Access Compliance Report

Public Rights-of-Way

(Pedestrian Signals)

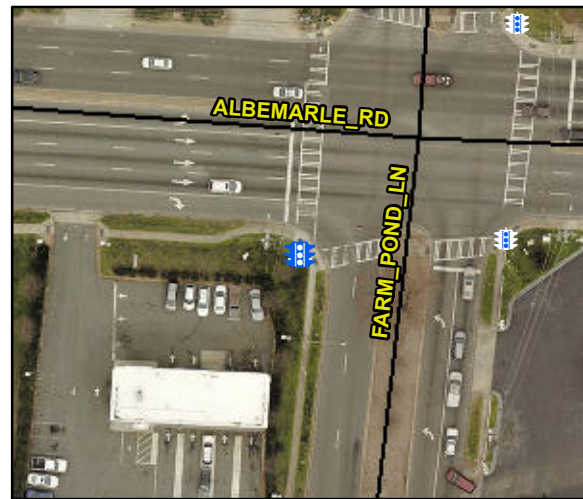
Surveyor Notes: TEXT HT 7/16

PROW/ADA: R410.6, TMUTCD 4e.08, R404.2, R406.2

Possible Solutions: Replace Signal Push Button With APS Button on New Post. Remove & Replace Sign.
